PROJECT : DEVIATIONS TO APPROVED
PLAN NO : 11/04/245
15 BRITTLEWOOD
ERF 325 PORTION 15 (OF 4)
OF ZIMBALI WEST
PORT ZIMBALI

RATE NUMBER :
DRAWING TITLE : SUBMISSION WORKING DRAWINGS

: FIRST FLOOR PLAN
: ENCROACHMENT TRADE OFF

DRAWING NO. : 2012_07_18_003

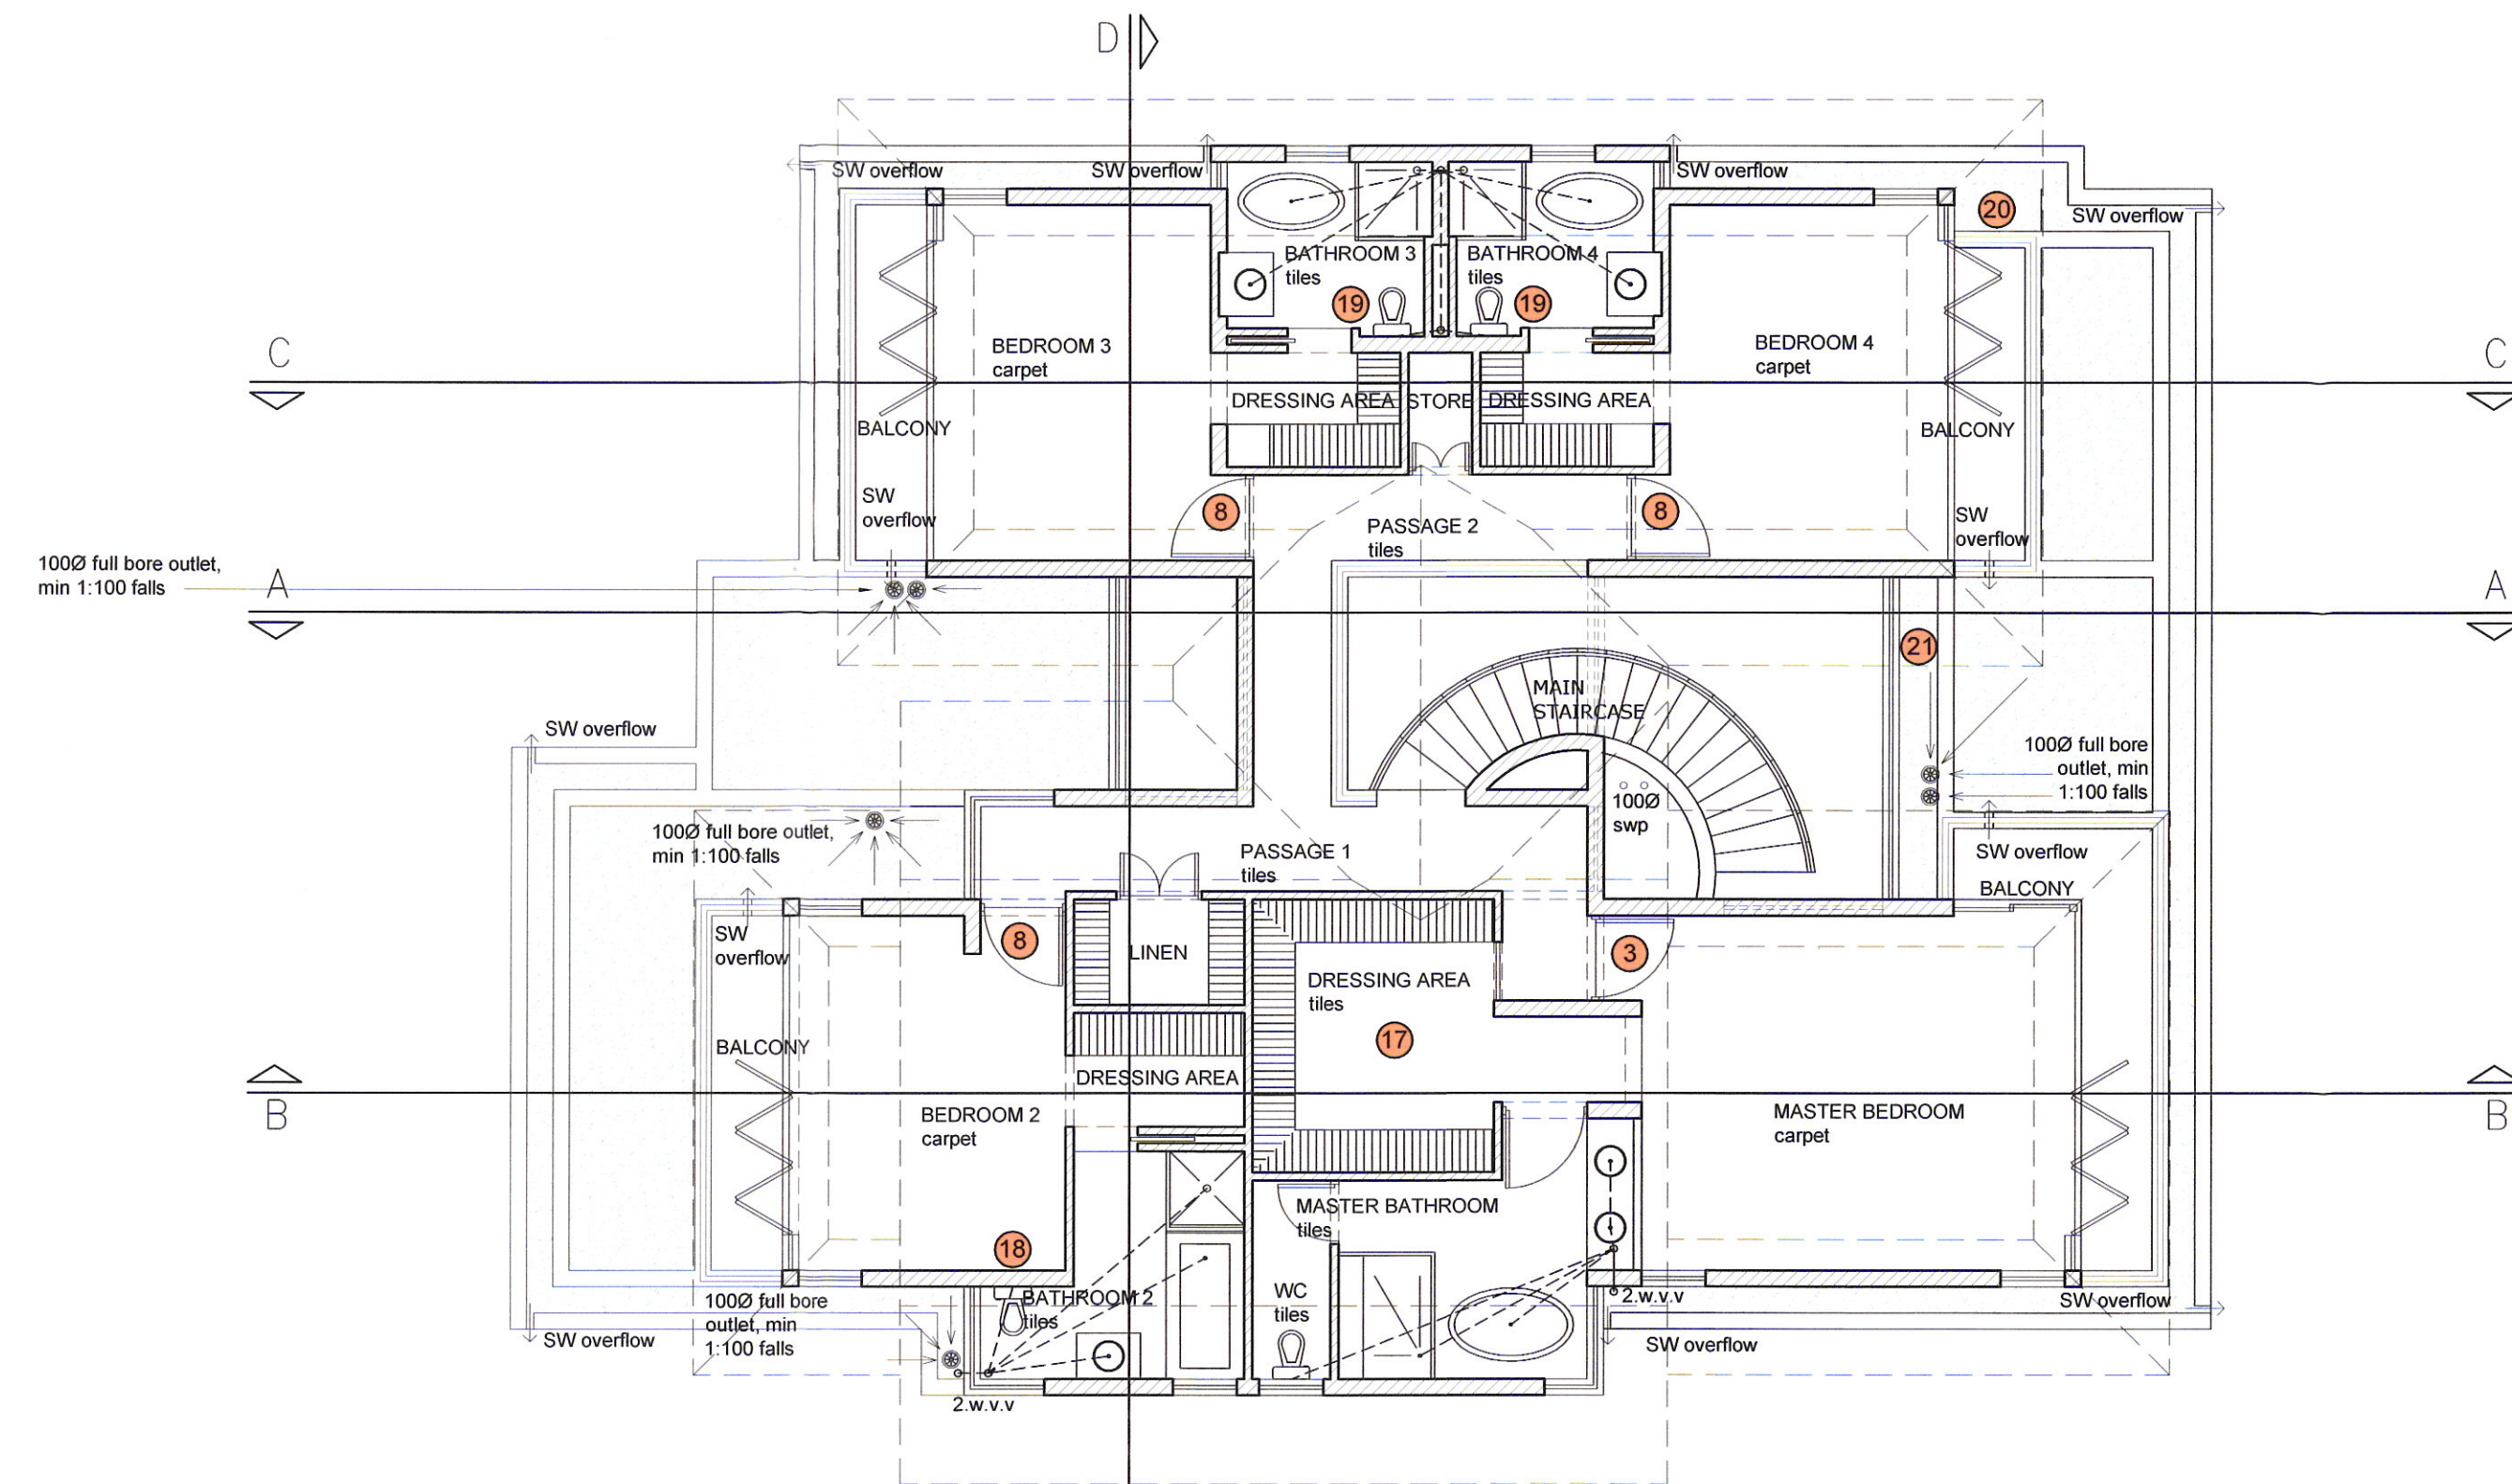
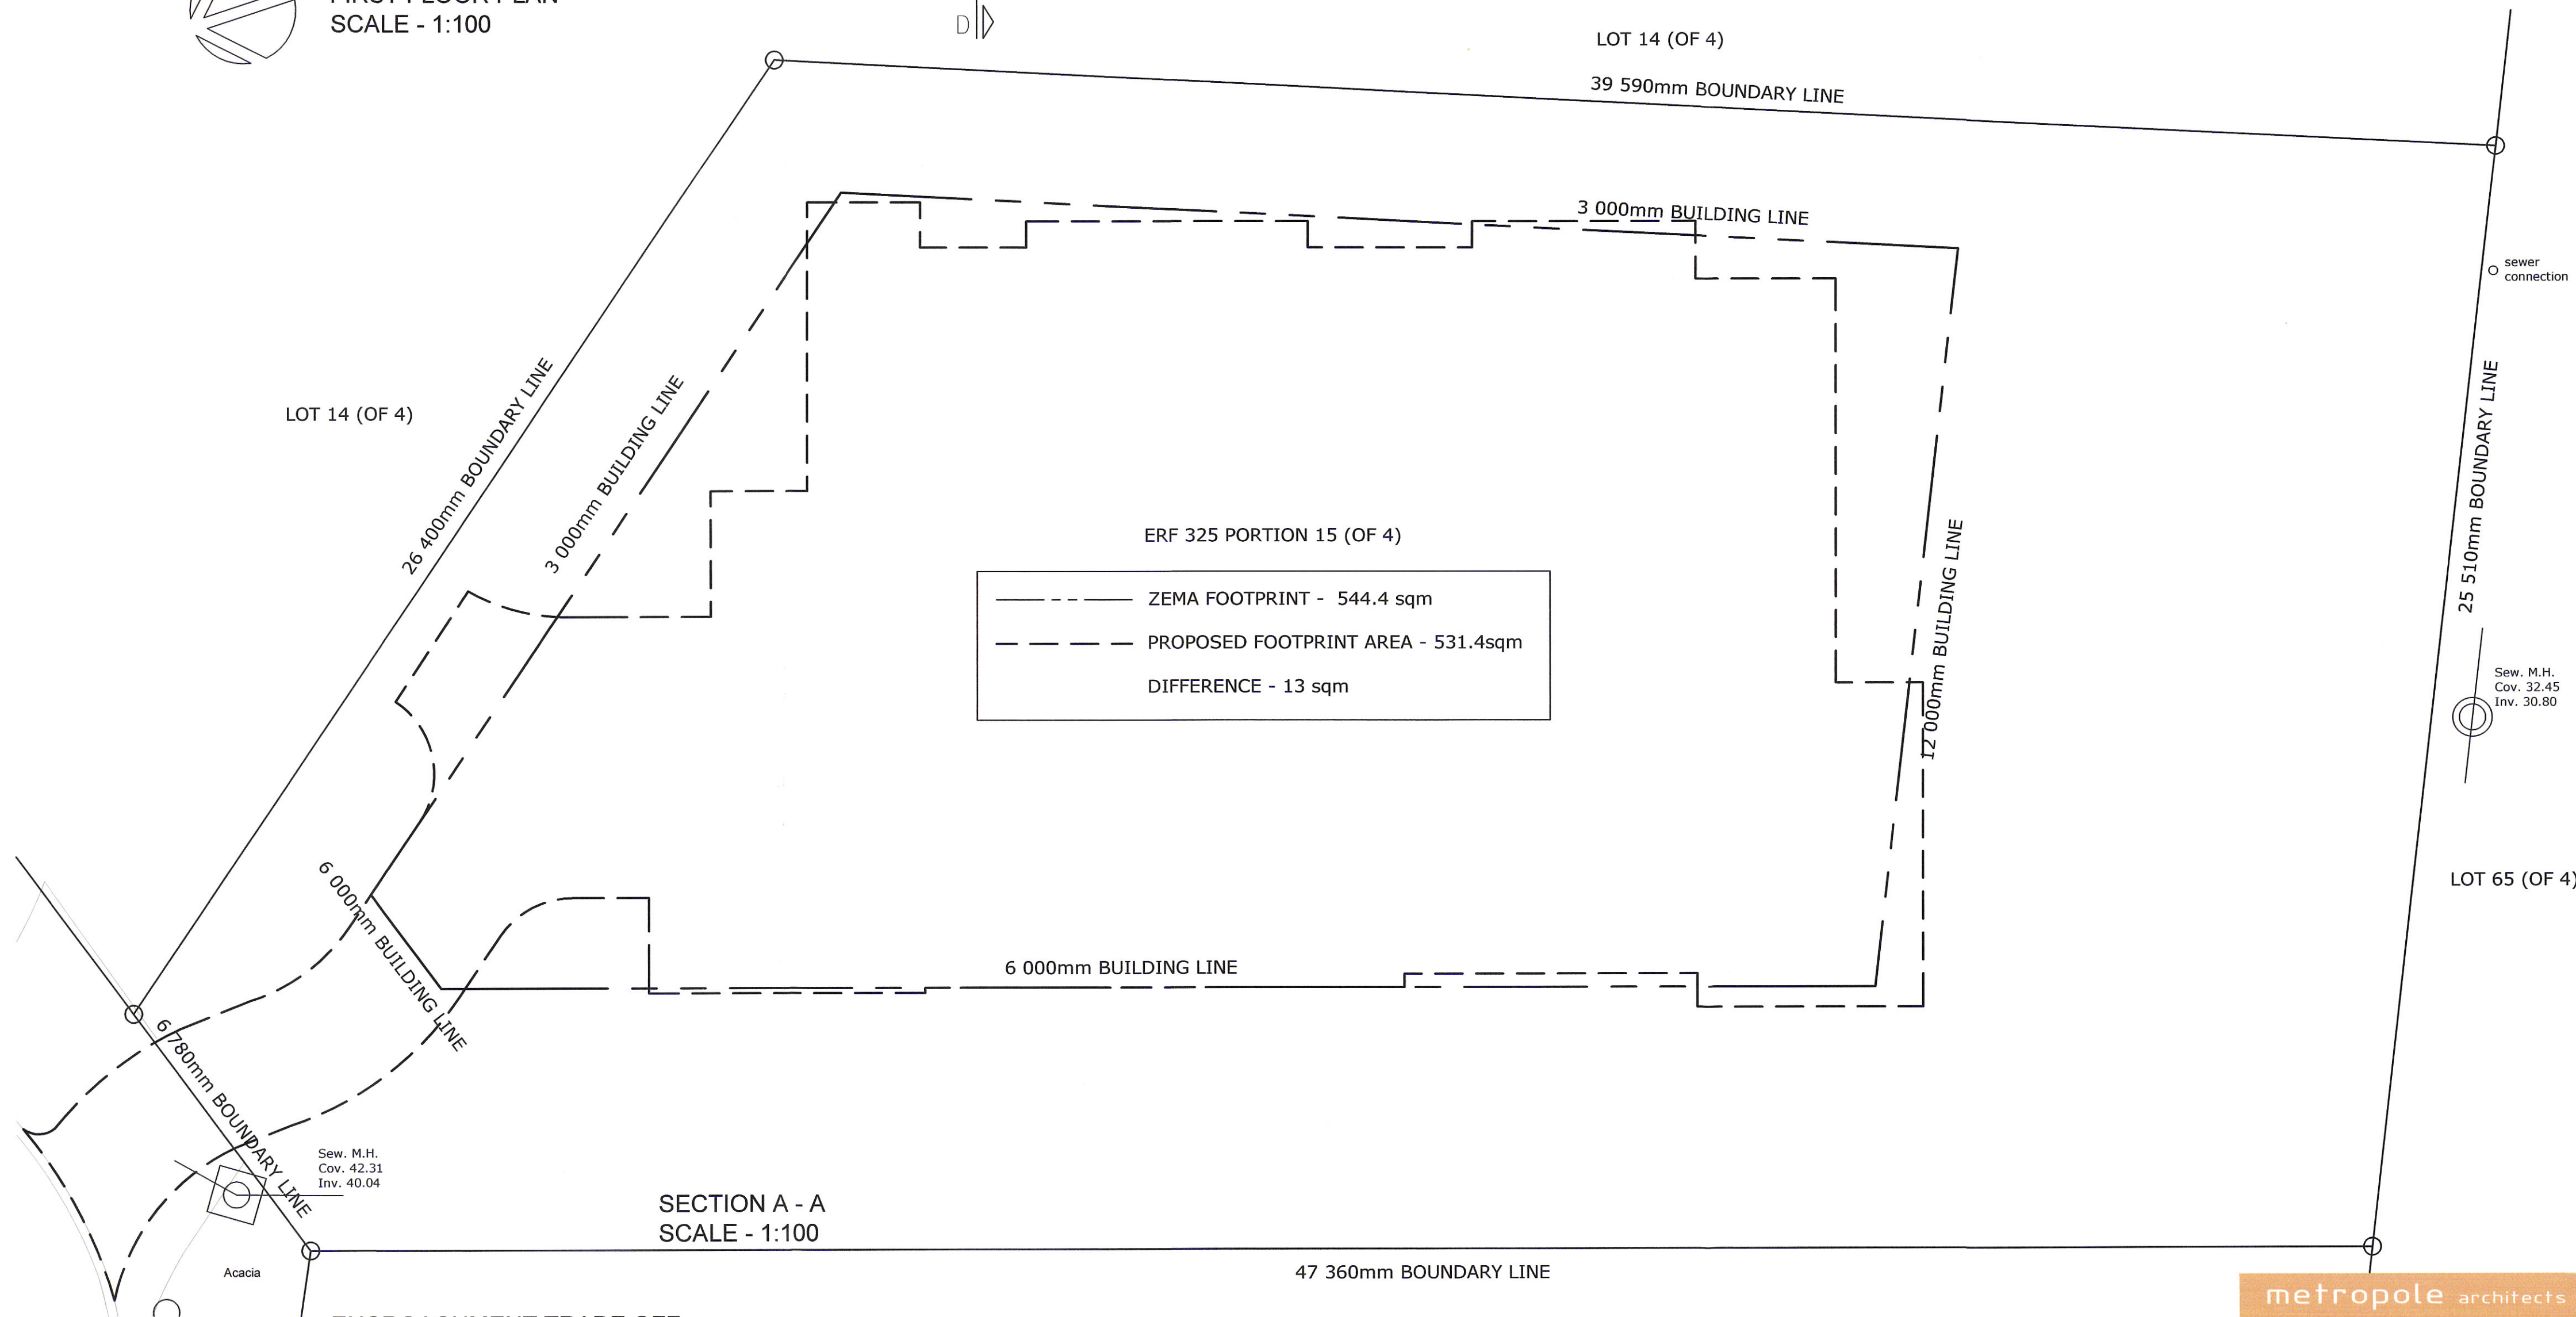
1. SHOWER ADDED IN GUEST WC & WINDOWS REVISED
2. STUDY REVISED TO GUEST BEDROOM & CUPBOARDS REMOVED
3. DOUBLE DOORS REVISED TO SINGLE DOOR
4. TIMBER SCREEN ADDED FOR AC UNITS
5. TV ROOM WINDOW REVISED
6. BAR REVISED
7. YARD WASH TROUGH REMOVED
8. DOOR SWING REVISED
9. PAVED WALKWAY ADDED
10. PANTRY DOOR REMOVED
11. STEP & RAMP DOWN ADDED
12. TIMBER BALUSTRADE ADDED
13. POOL PUMP POSITION REVISED
14. STORM WATER GRATE ADDED
15. POOL AREA REVISED & ASTRO TURF ADDED
16. JACUZZI REVISED
17. DRESSING AREA REVISED
18. TOILET REPOSITIONED IN BATHROOM 2
19. GLASS ELEMENT REMOVED
20. BEDROOM 4 BALCONY REVISED
21. ROOF SLAB REVISED
22. STAFF WC & LOUVERED DOOR ADDED
23. ROOF REVISED
24. RETAINING WALL ADDED
25. STONEWORK REMOVED AND WALL HEIGHT REVISED
26. SCULLERY WINDOW REVISED
